Your Ref	SSD-84699461
Our Ref	NCA/16/2025
Contact	Douglas Bennett
Telephone	02 9806 5405
Email	dbennett@cityofparramatta.nsw.gov.au

COUNCIL SUBMISSION TO REQUEST FOR ADVICE ON ENVIRONMENTAL IMPACT STATEMENT – MIXED-USE DEVELOPMENT WITH IN-FILL AFFORDABLE HOUSING (SSD-84699461) AT 241-245 PENNANT HILLS ROAD, CARLINGFORD

Appendix 1 – Key Matters

Gross Floor Area Calculations

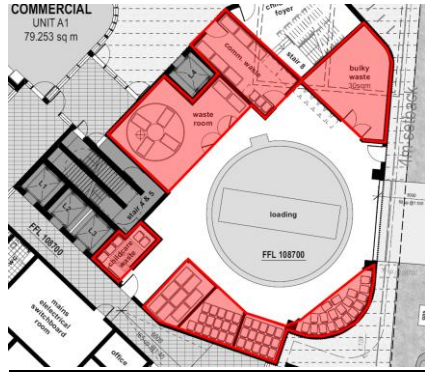
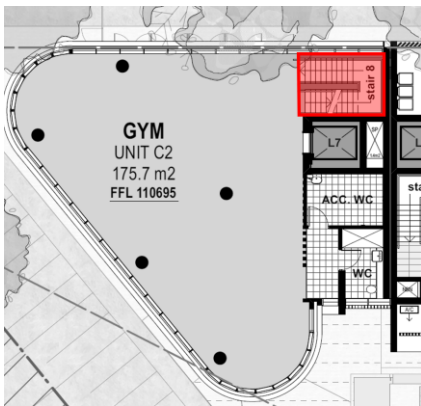
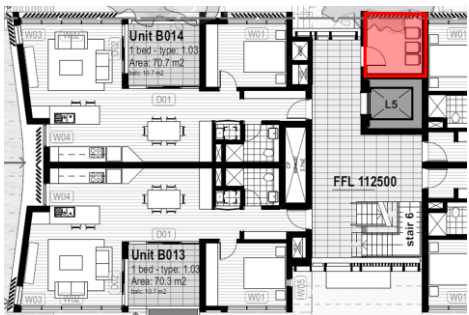
Upon review of the gross floor area calculations provided by the proponent, it is evident that the total gross floor area of the proposed development has been incorrectly calculated. In summary, the applicant has calculated a total floorspace of 15,738sqm (16,203sqm including 465sqm winter garden allowance) whilst Council calculates a total of floorspace of 16,722.7sqm (17,187.7sqm including 465sqm winter garden allowance).

There are numerous areas within the gross floor area calculations provided by the proponent that have been incorrectly excluded. A summary of these areas is provided in the following table.

Building & Level	Component	Area (estimate)	Comment
Ground, Building A	Waste storage areas. 	152.5sqm	As per the definition of gross floor area, only basement garbage/waste areas are excluded from counting towards gross floor area. The several waste storage areas located at the ground floor of Building A must therefore be counted as gross floor area.
Ground – Level 1, Building A	Childcare foyer & stairs	35.6sqm	The childcare foyer area has been erroneously excluded from GFA

calculations, despite no clear exclusion criteria applying to such an area. In addition, it is noted that the stairs serve a sole (non-residential) occupancy in the building and do not provide 'common' vertical circulation (see <i>Chami v Lane Cove Council [2015] NSWLEC 1003</i> paragraphs 273-275). As such, the stairs must be included as gross floor area.
Ground – Level 2, Building C	Stair 8 	22.8sqm	Stairwell 8 serves a sole commercial (gym) tenancy within Building C and therefore should be included in GFA calculations.
Level 1 – Level 3, Building C	Waste storage rooms 	22.5sqm	As the definition of GFA does not exclude waste storage areas above basement level, the waste storage rooms on levels 1-3 in Building C must be included.
Level 1 – Level 3, Building B	Waste storage rooms 	21.3sqm	As above.

Figure 1 *Path of Travel for Delivery of Goods*

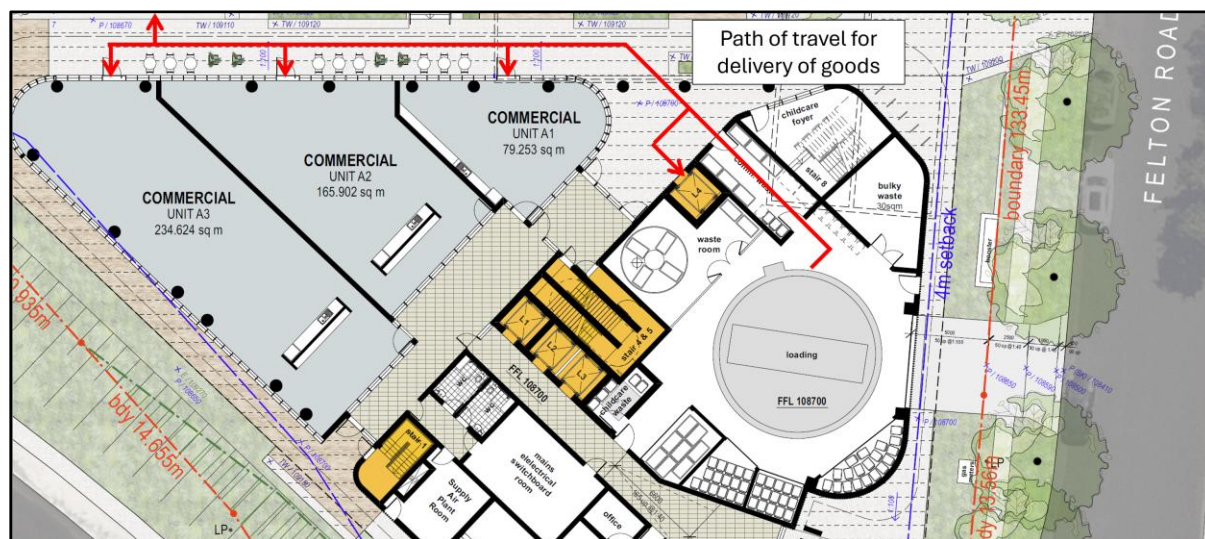
Council notes the provision of a loading dock within the ground level of Building A, to be used for the collection and removal of waste as well as deliveries for the site. The provision of multiple waste storage rooms within close proximity to the loading dock would facilitate efficient waste removal. However, the separation of this loading dock from commercial storage areas located within Basement Level 1 is considered to be impractical. Any goods delivered to the site would need to be transported through waste rooms (with narrow doorways) and to the commercial premises located within Buildings A-C or transported via Lift 4 to Basement Level 1 which is understood to be a passenger (and not goods) lift.

The absence of dedicated storage space for the delivery of goods and easy access to commercial storage areas from this loading dock is considered to be poor design. In addition, the need to transport goods (including food deliveries) through waste storage areas may give rise to adverse public health outcomes.

Council recommends that the ground floor loading dock be redesigned to include appropriate facilities to receive the delivery of commercial goods. In addition, it is recommended that a

dedicated goods lift be incorporated into the loading dock, to enable transportation of goods from the loading dock to the basement commercial storage areas.
